Agenda Item 3
1425 Telegraph Road
Continued Consideration of a New House on a Vacant Lot

1425 Telegraph Road

Continued consideration of plans for a new two-story single-family residence and the associated hardscape and landscape on a vacant lot.

Summary of Request

SITE PLAN 12/4/2024

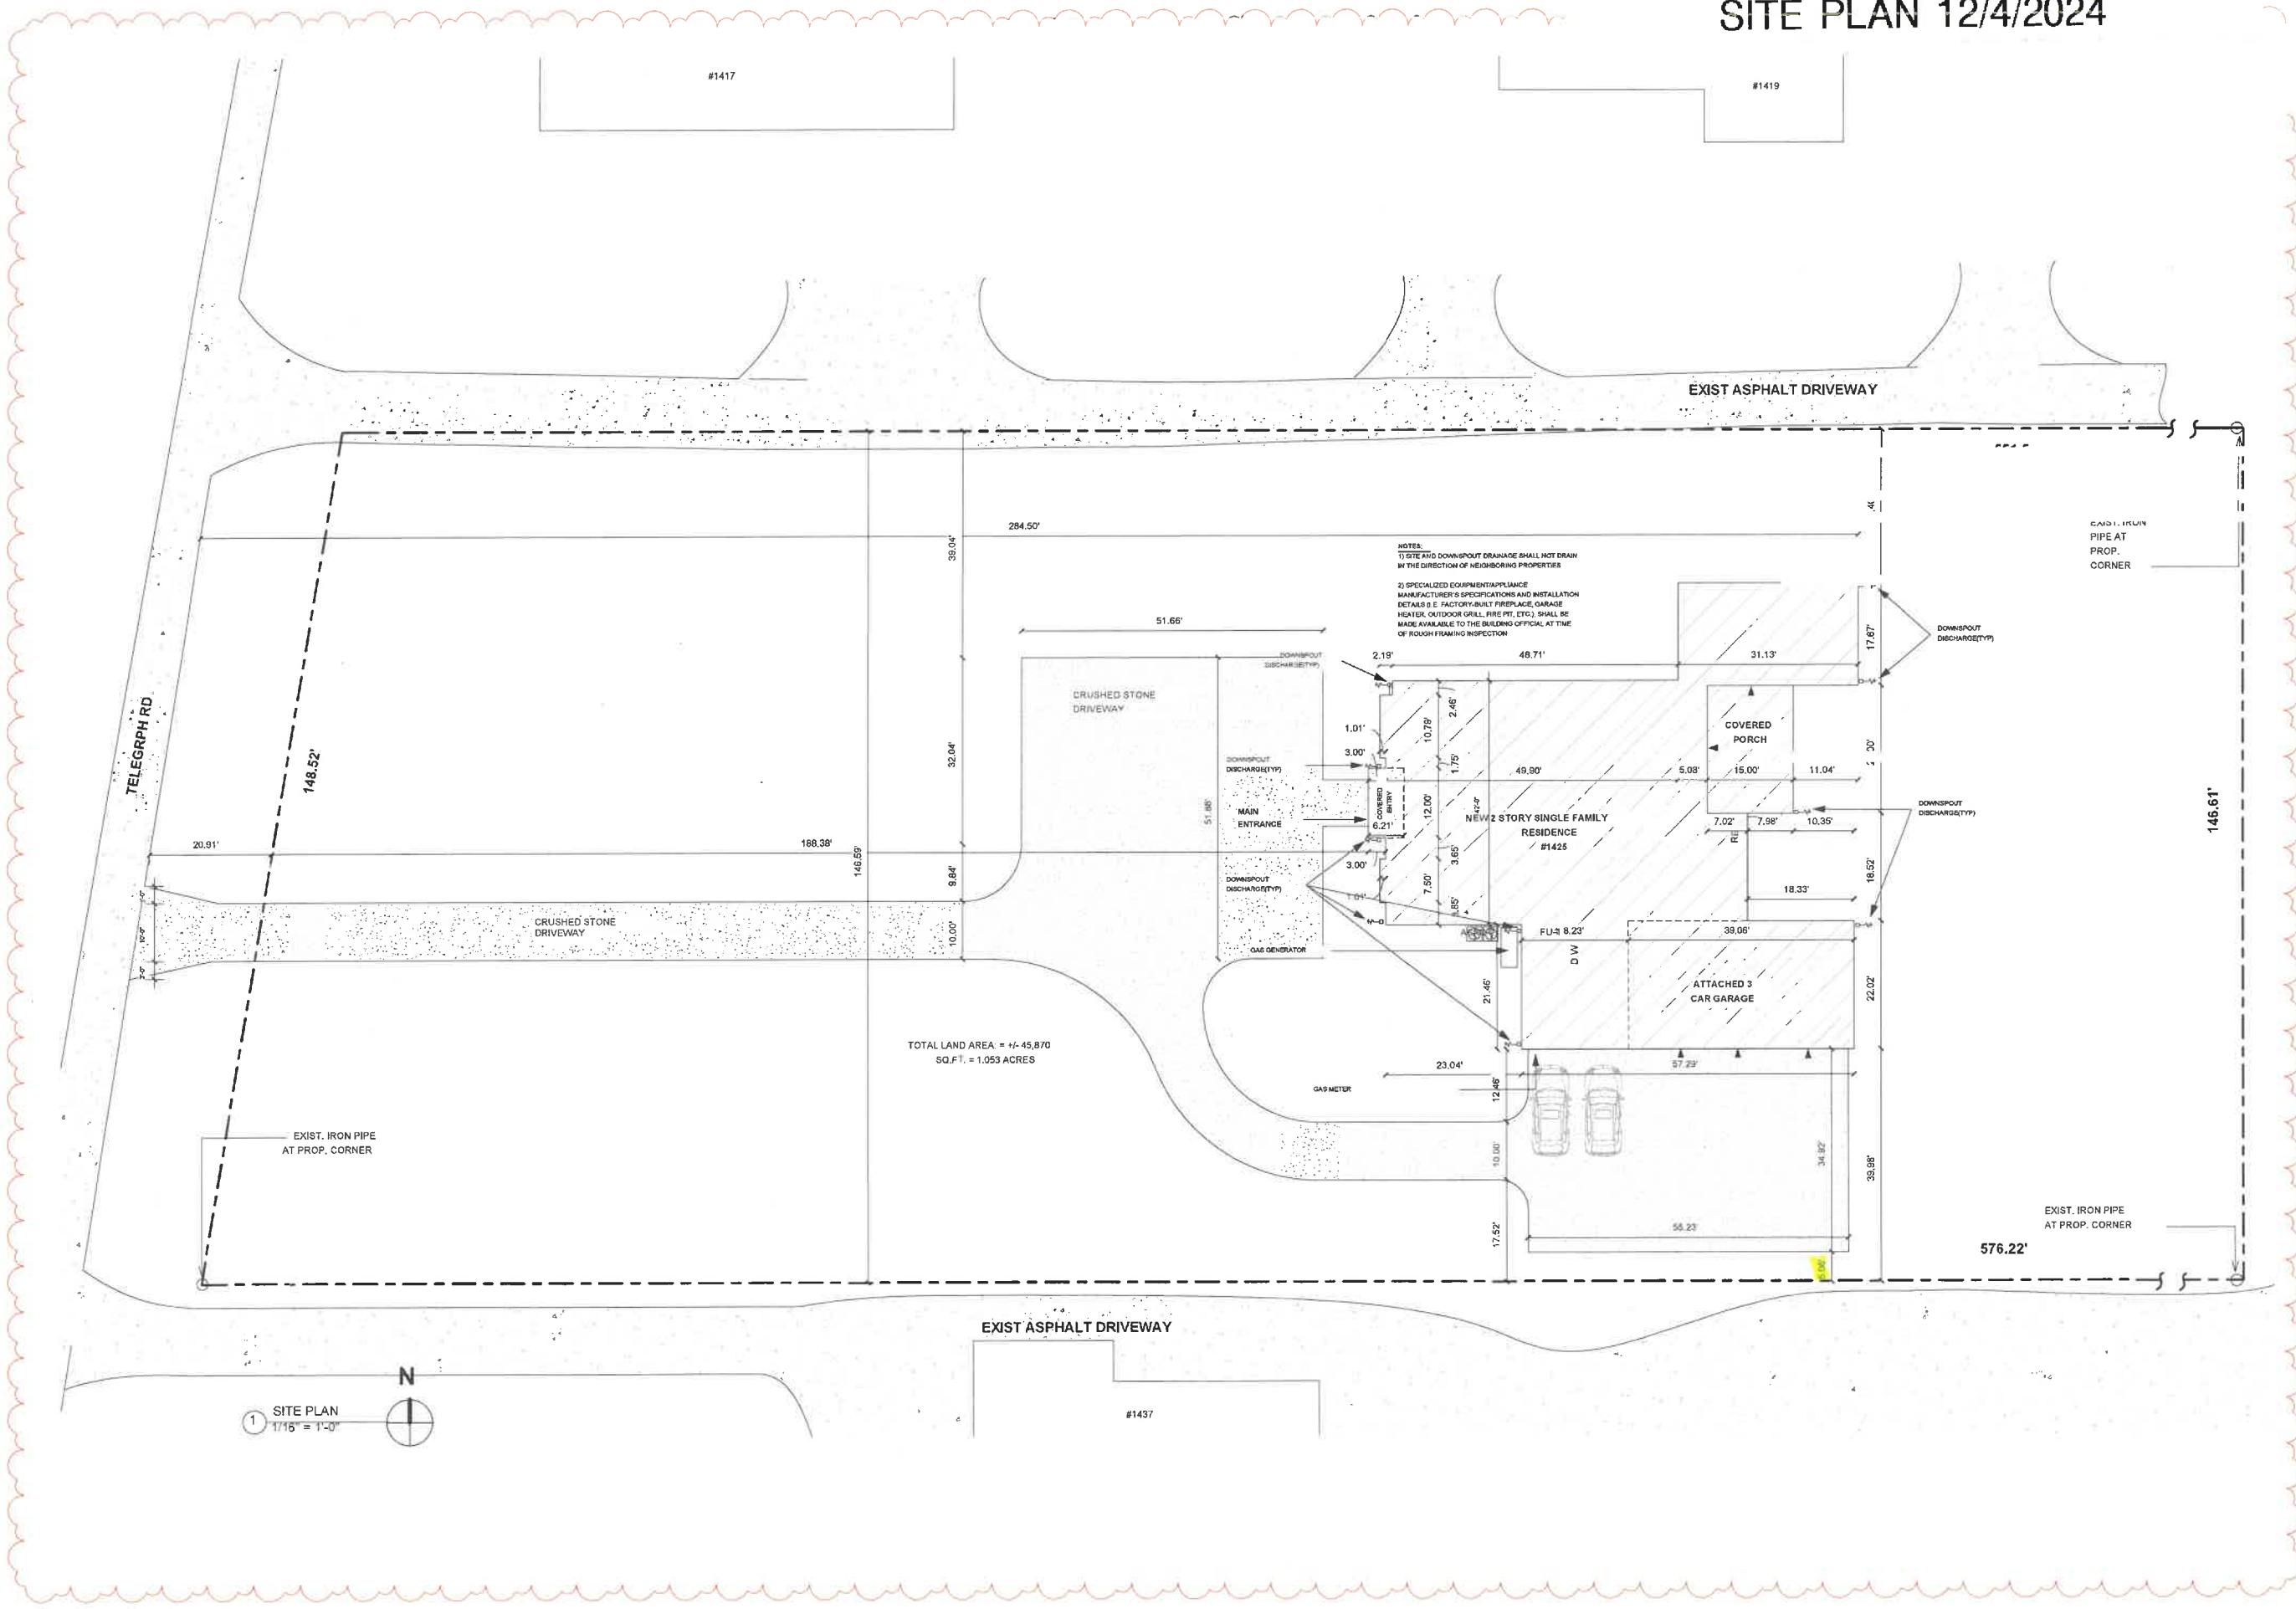
In response to comments of the Board, the circular feature of the driveway was removed, the 90-degree turn into the driveway as it approaches the garage was softened and a buffer was created between the garage apron and the neighboring property. Given the large expanse of the lot and the large home proposed, it will be important to assure sufficient land area along the north and south property lines to support substantial layered perimeter landscaping of varying heights to provide a year round buffer between the mass and light spillover of the new residence on to the smaller residences to the north and south.

Consideration does not appear to have been given to exploring orienting the house to the north as suggested at the last meeting.

Staff Recommendation: Widen the buffer along the south property line, at the edge of the driveway to a minimum of 10 feet to provide adequate space for substantial plantings.

The driveway has been adjusted and the circle replaced for a rectangular one per the board's suggestion.

The requested site plan showing the neighbors has been added to the presentation.

SHEET No. **A204**

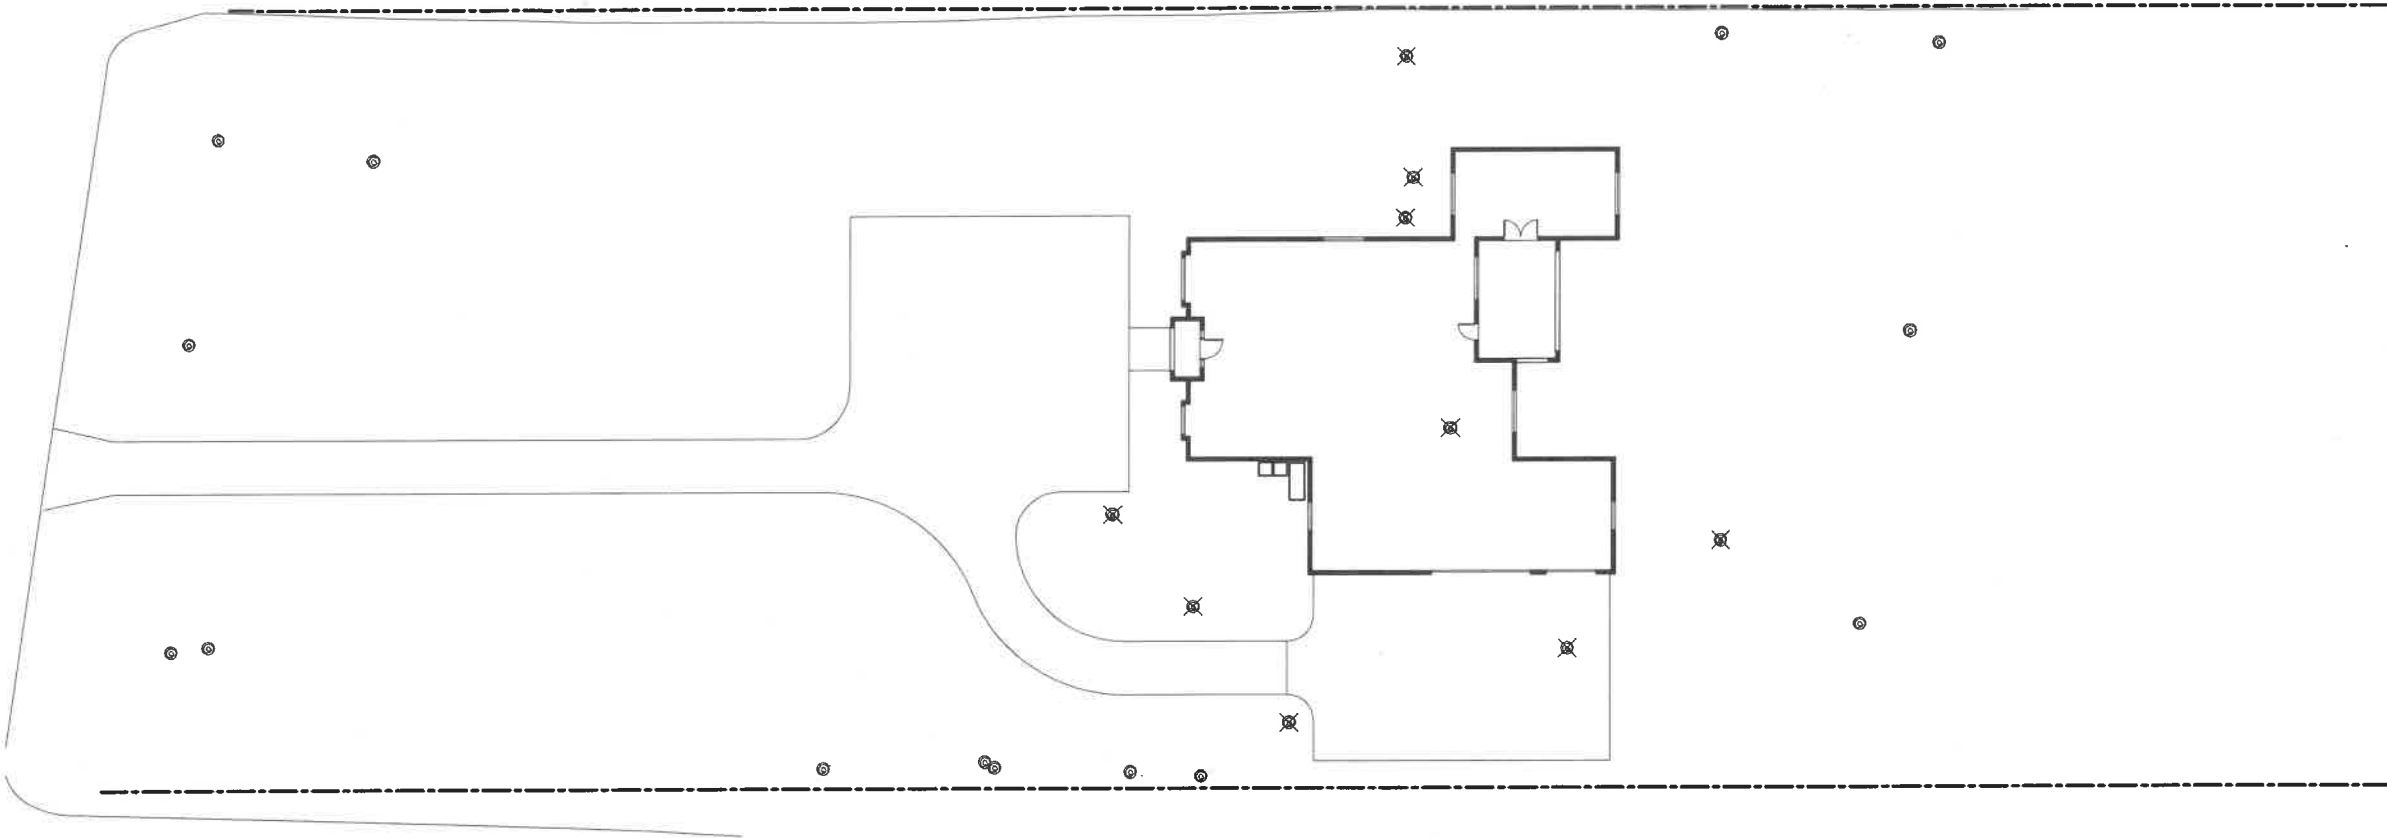
Elevations – This standard could be more fully met with further refinement of the massing, roof forms, window placement, and detailing.

In response to comments from the Board, the hipped roof over the central mass was widened and saddles were added to address water drainage.

To address the elevation comments, the main roof has been adjusted to provide a consistent roof pitch. The roof saddle has been increased to provide proper roof drainage and the garage windows have been redesigned. A 3D model has been added to better show the size and depth of the front entrance, roof angles and positioning of the side structures.

LANDSCAPE PLAN

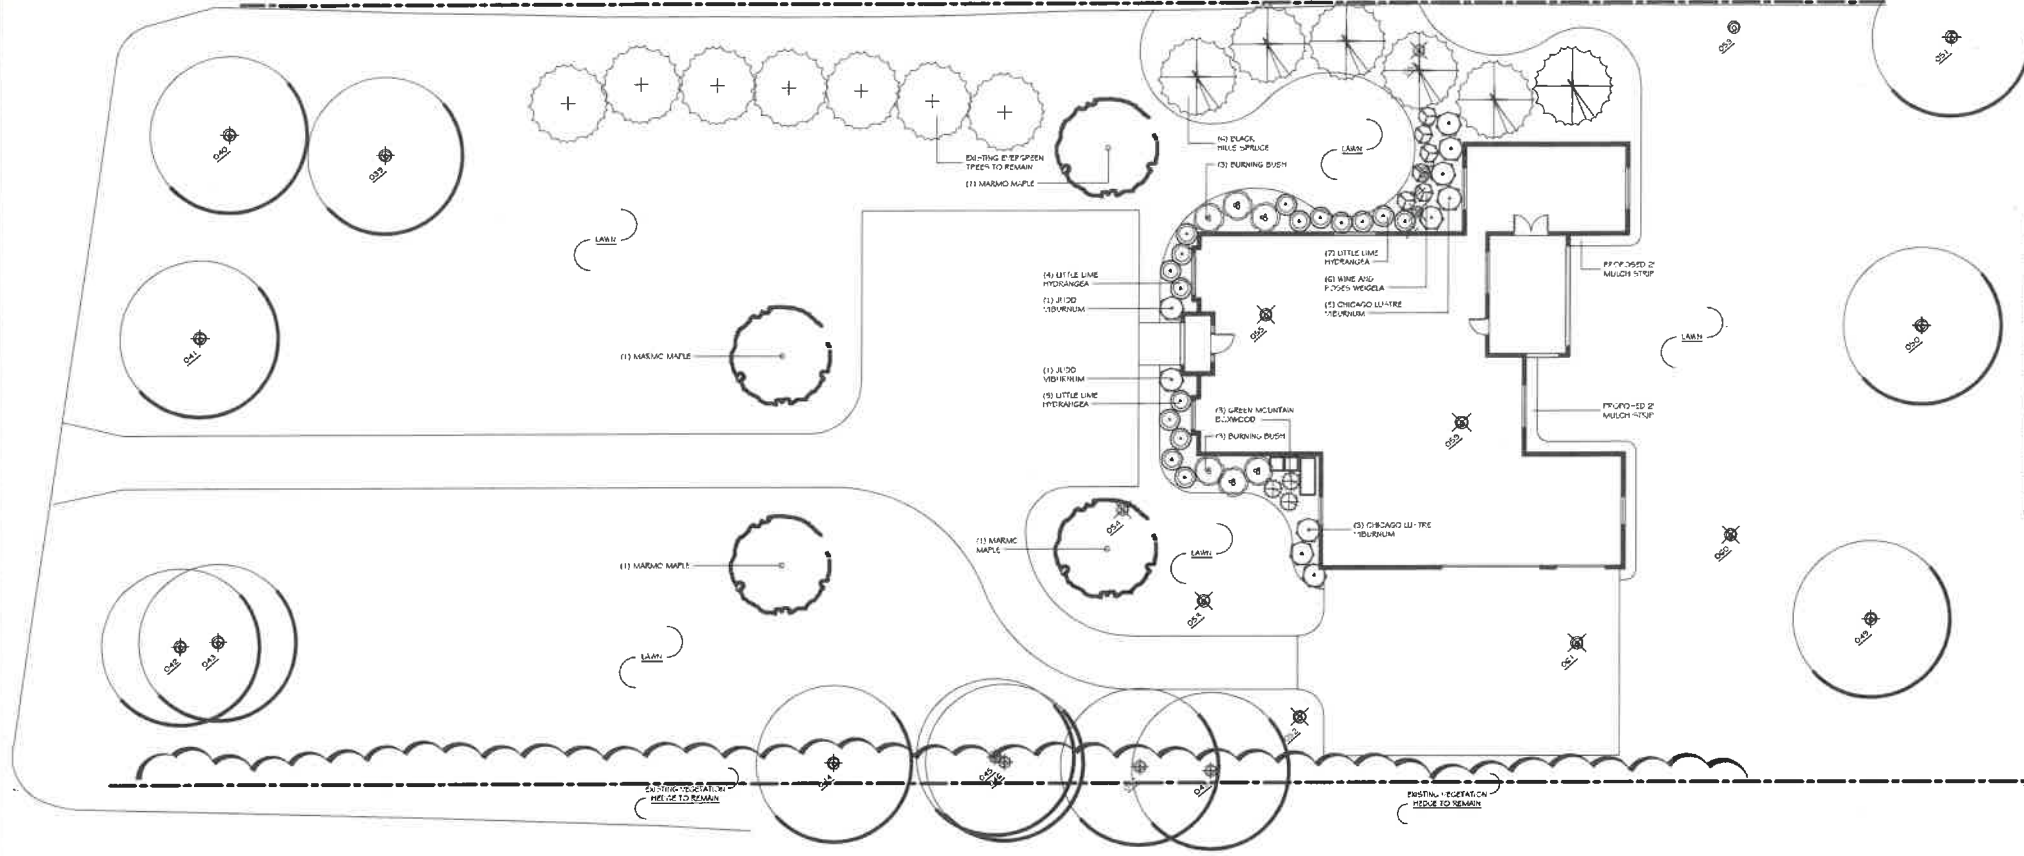
The proposed plan satisfies the minimum criteria for new construction however, given the size and height of the home, and the expansive hardscape proposed, layered plantings of different heights along the north and south property lines and in the front yard to soften the streetscape, will allow the new residence to settle more quietly into the property and into the neighborhood.

A complete landscape plan has been added.
